**PARTS & SERVICE  
NEWS**

REF NO.	<b>AT04060</b>
DATE	<b>Apr. 16, 2004</b>
(C) Page 1 of 3

**SUBJECT:** IMPROVED PILOT LAMP FOR SEESAW SWITCH ON WA-5 (GALEO)

**PURPOSE:** To introduce modification procedure to replace the seesaw switches with built-in pilot lamp on the WA-5 type wheel loaders (GALEO) when filament disconnection failure occurs with the pilot lamp

Fig. 1

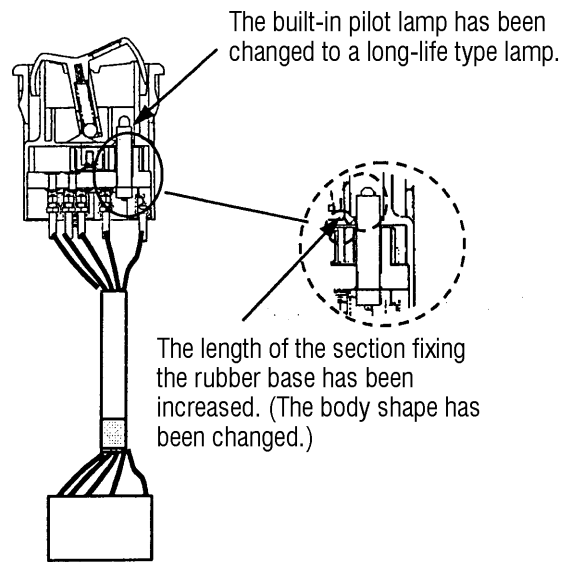
3. The length of the section fixing the socket of the pilot lamp being built into the switch has been increased to improve the vibration resistance, and at the same time, the power consumption of the lamp has been reduced to extend its life, thus preventing occurrence of filament disconnection failure of the lamp.

Simultaneously, since the brightness of the lamp is decreased by reduction of power consumption of the lamp, the permeability of the decal has been increased.

※ Note 1)  
 This improvement is effective only when the modifications of the switch body and the lamp are combined. If the new lamp as an independent spare part is installed to the current switch, although it is possible to install the new lamp into the current switch, they are not effective for this improvement. Therefore, when the filament disconnection failure occurs, be sure to replace the current switch itself with the built-in pilot lamp.  
 The new lamp can be installed only to the new switch as a spare parts.

Fig. 2

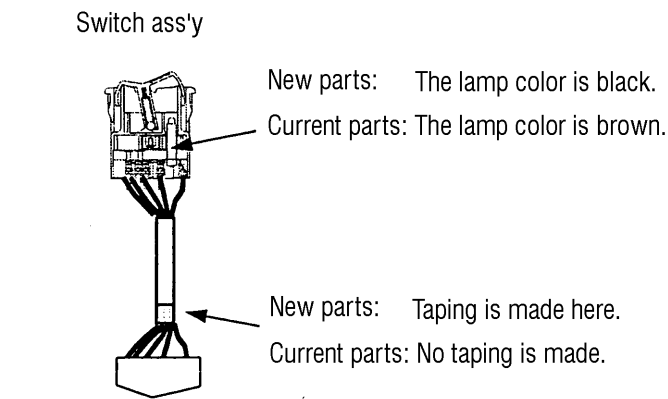
Identification of the new and current parts:

Fig. 5

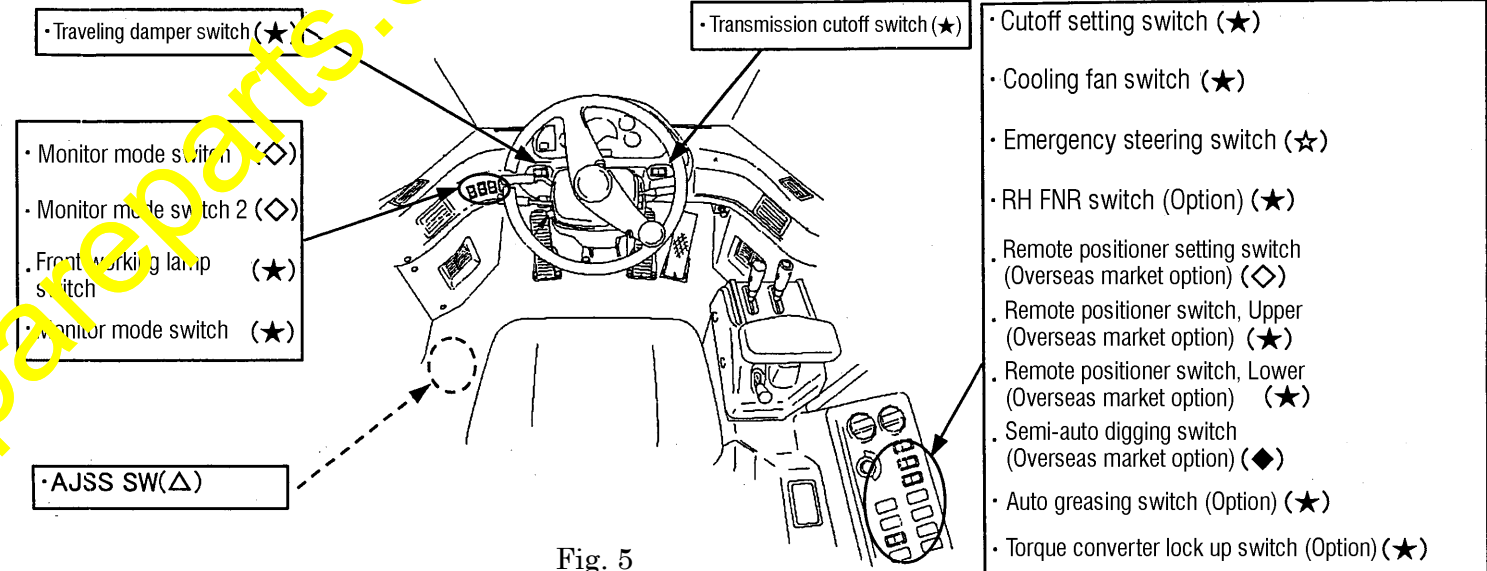
Process 1) Remove the seesaw switches and replace them with the new switch of the corresponding part number indicated in the table below, and after that, stick the corresponding decal.

Installed positions and part numbers of the main seesaw switches
